BOTLEY WEST SOLAR FARM (BWSF) REF: EN010147

Cumnor Parish Council's Submissions at Issue Specific Hearing 2 9th October 2025 for Deadline 6

Cumnor Parish Council's Submission at Open Floor Hearing 3 10th October 2025 for Deadline 6

Figure 1

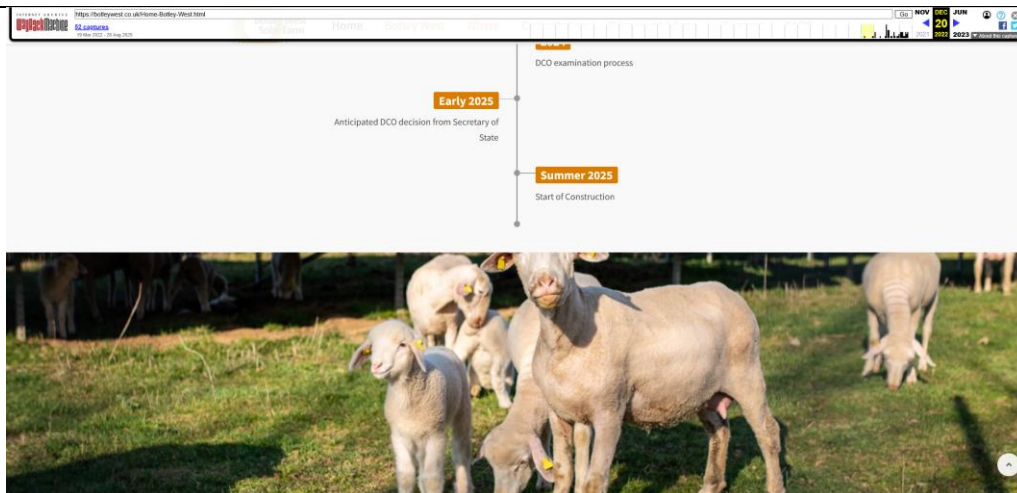
20/12/2022 No connection date quoted at the start of the Phase 1 Community consultation and some 12 months, according to the applicant, after an October 2026 connection date was agreed with NGET in 2021

Figure 2

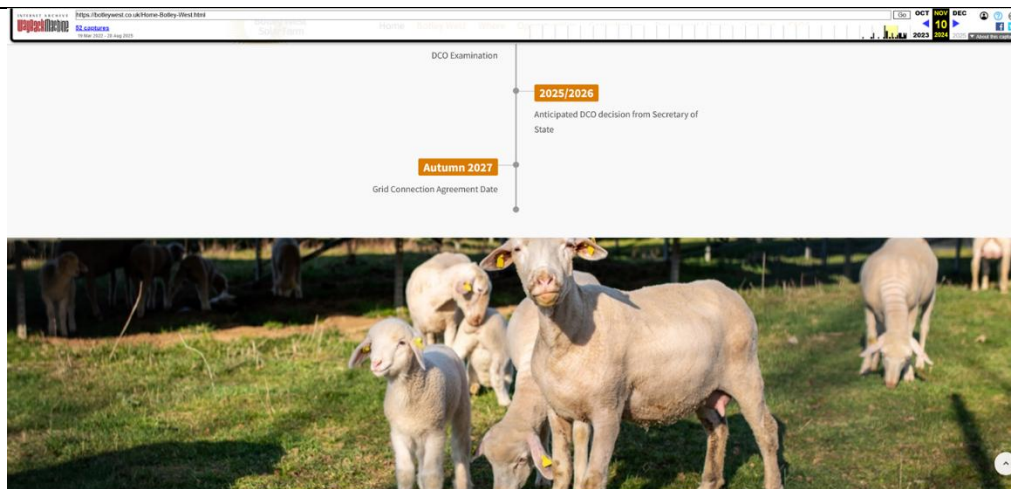
03/12/2023 Connection date of Autumn 2027 claimed some 12 months after the website snap shown above and now 2 years since claimed 2021 agreement with NGET for connection in 2026

10/11/24 Connection date of Autumn 2027 claimed at the time of the NSIP application to PINS and now 3 years since claimed 2021 agreement with NGET for connection in 2026

Figure 4

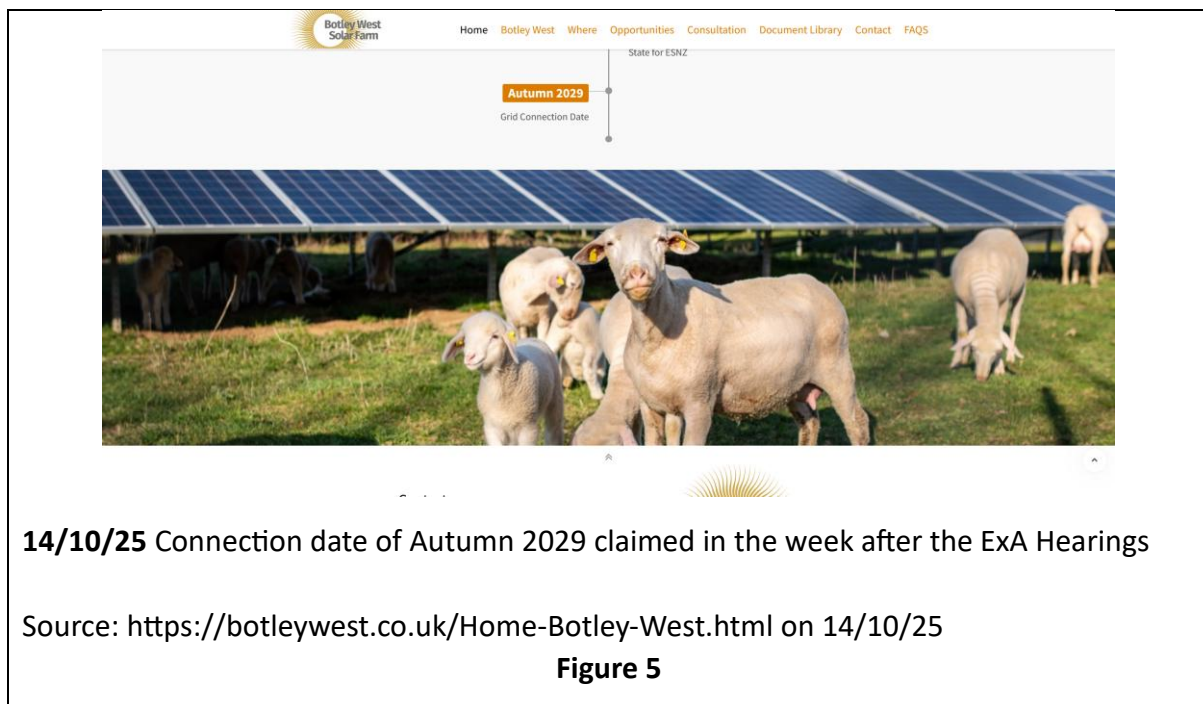
07/10/25 Connection date of Autumn 2028 claimed in the week of the ExA Hearings and now 4 years since claimed 2021 agreement with NGET for connection in 2026

Figure 7

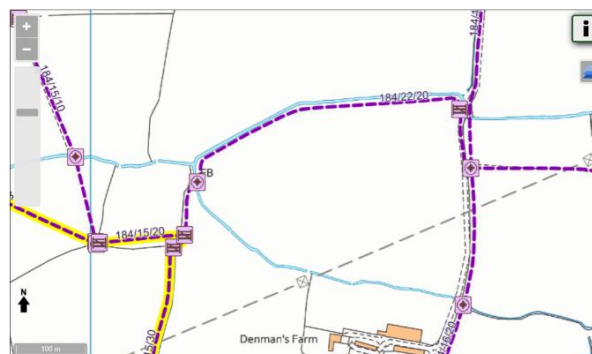
1. In response to the question ExA posed to the applicant about the apparent north-south axis straight line of modelled flood zone 3 in Figure 1.1 on page 2 of Hydrology and Flood Risk Technical Note 2 in CR2-071, CPC can confirm that there is no topographical feature there to account for this (see Figure 7 below left).

To assist the ExA, CPC shows (Figure 7 below right) the same area as depicted in Oxfordshire County Council's Countryside Access Map⁷, showing the relevant impacted PRoW and watercourses.
